# UNITED STATES PATENT AND TRADEMARK OFFICE

<b>Office Action Summary</b>	Application No. 10/711,177	Applicant(s) CHIANG ET AL. 	
	Examiner Omar Rojas	Art Unit 2874

## **DETAILED ACTION**

A polarizing beam splitter 904 that is substantially 45 degree-inclined with respect to one of the side reflection mirrors, and is located with the light tunnel between the retardation plate 916 and the light exit face. Figures 9 and 10 of Dewald are reproduced below.

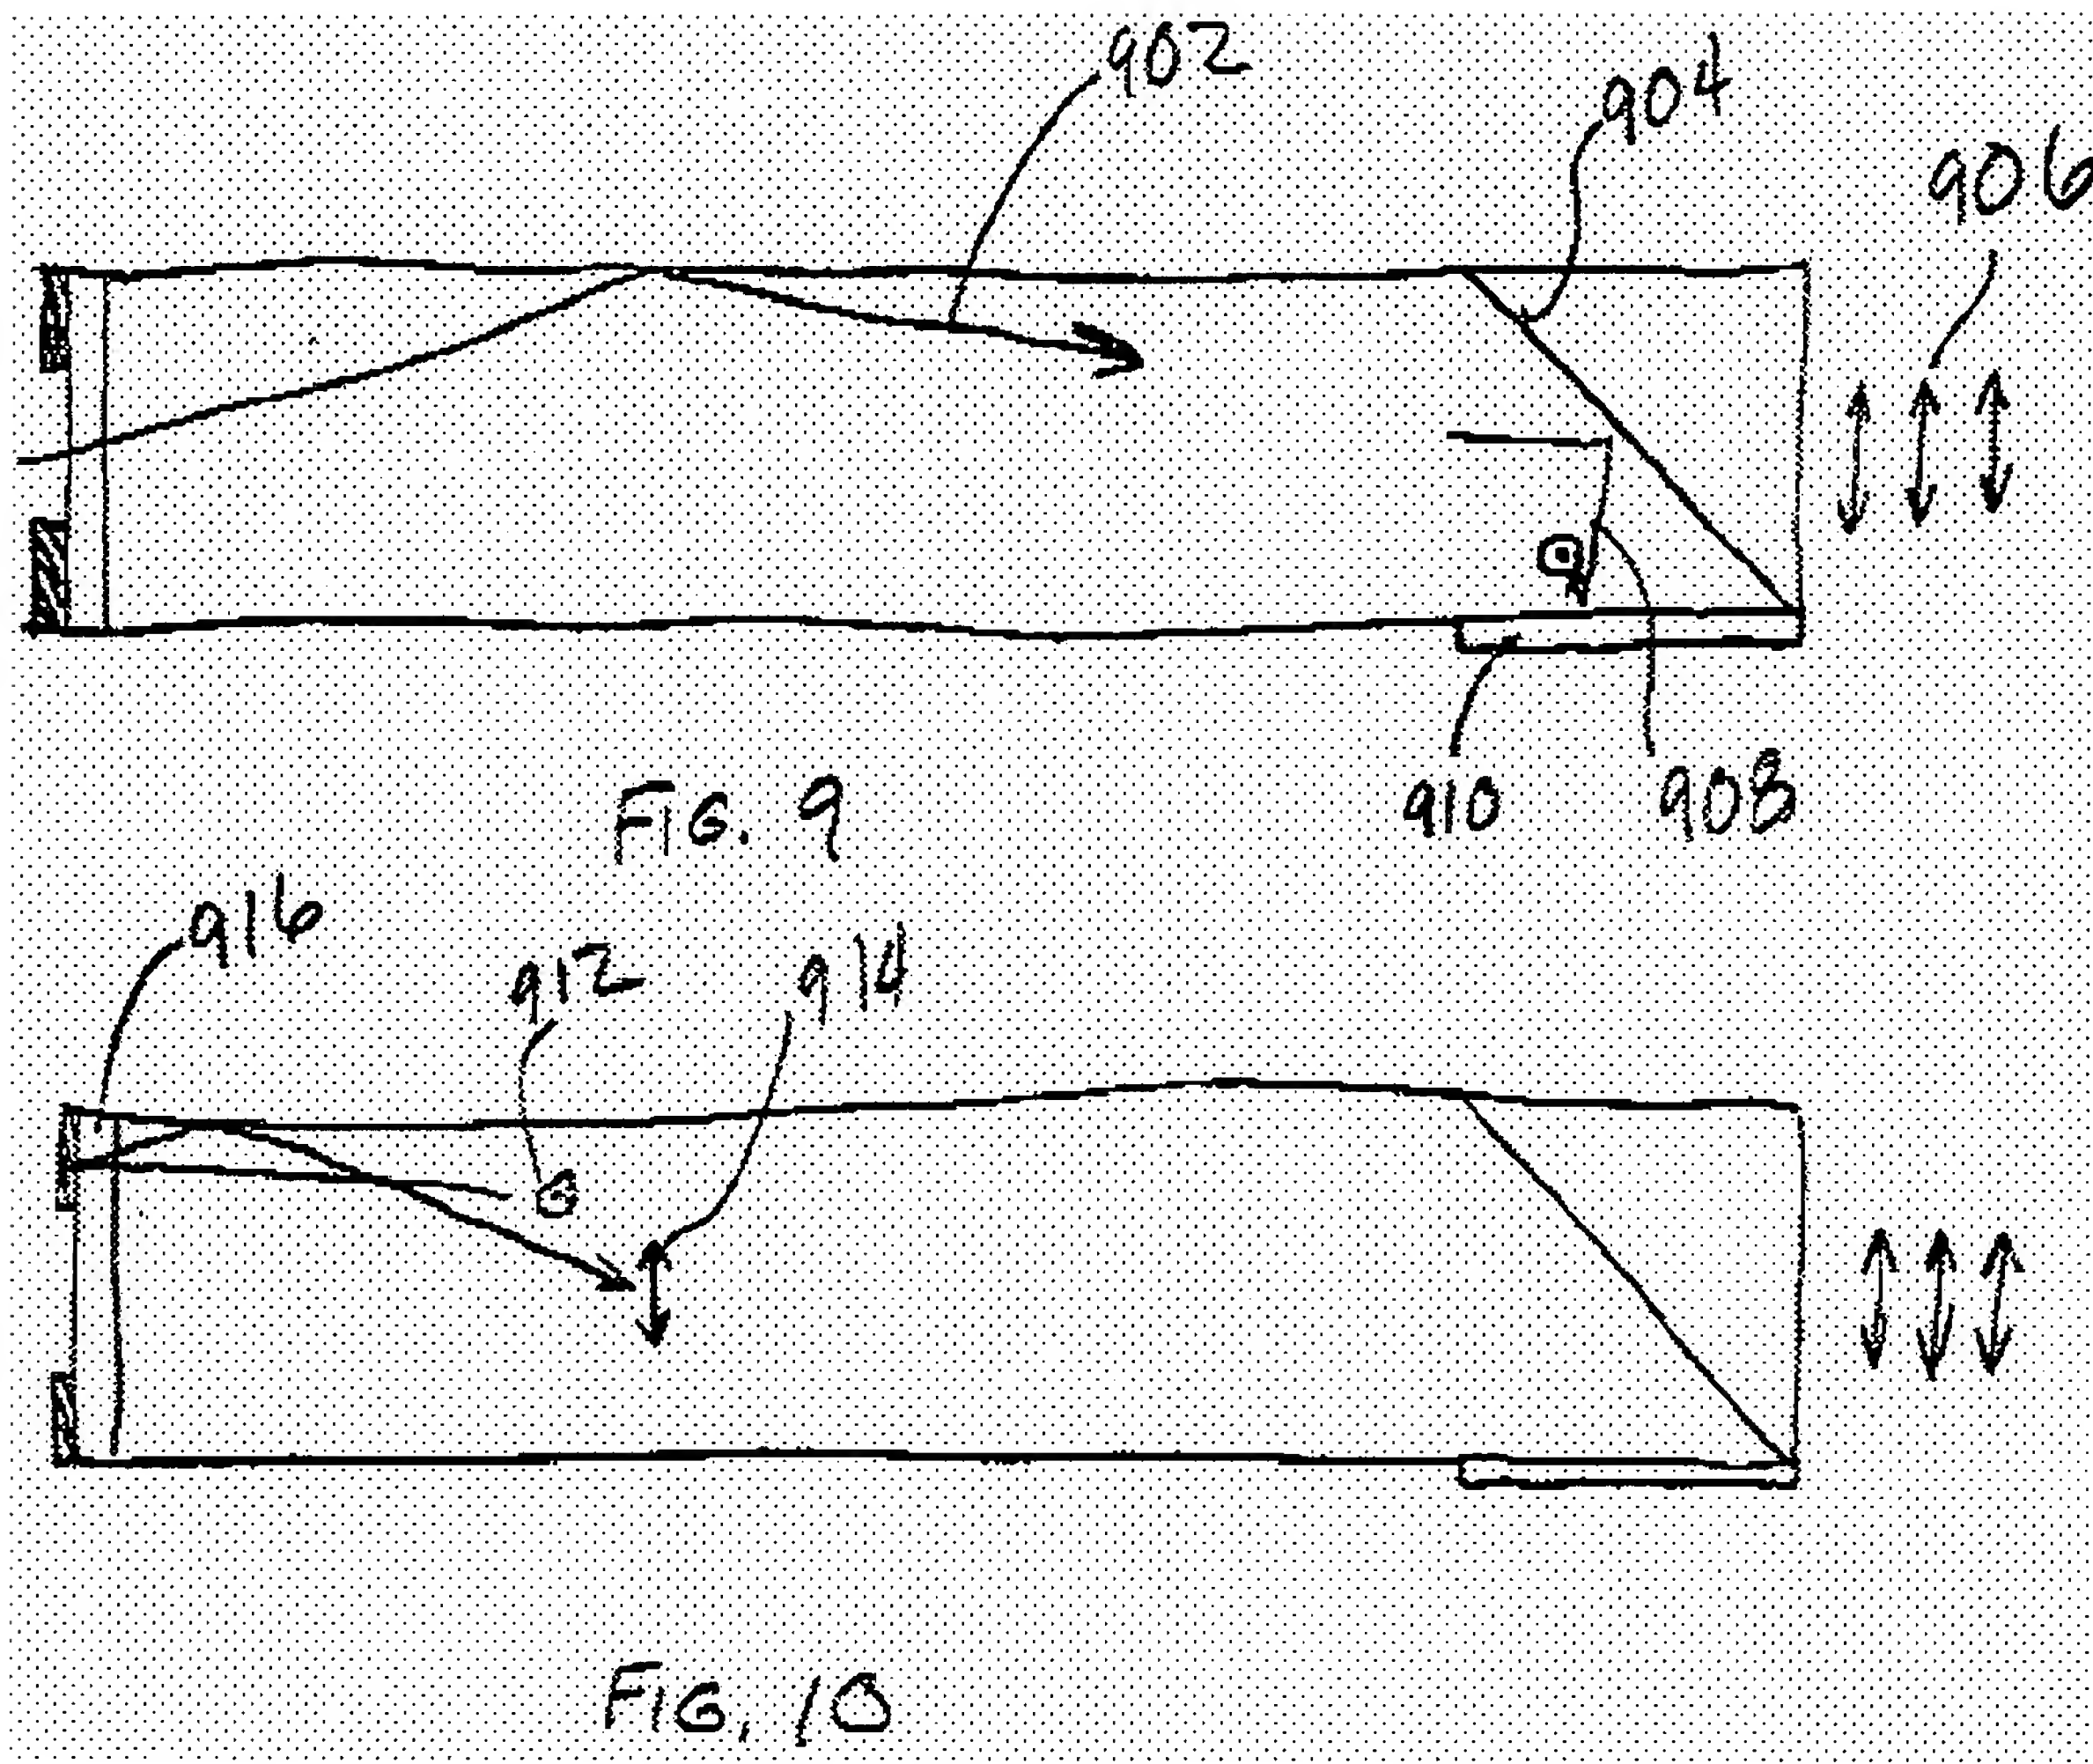
Regarding claim 1, Dewald discloses a polarization conversion light pipe device (Figures 9-10) comprising:

An integrating rod defined by four side reflective mirrors, wherein the light tunnel has a rectangular cross-section and has a light entrance face and a light exit face (see paragraph [0045]);

A front reflective mirror 302 (not labeled in Figures 9-10) mounted at the light entrance face with an aperture [0042];

A retardation plate 916 situated within the integrating rod;

Regarding claim 2, the limitation is inherently disclosed by Dewald because Dewald uses a quarter-wave plate for retardation plate 916.

Regarding claim 4, the polarizing coating 904 of Dewald functions a polarizing beam splitter.
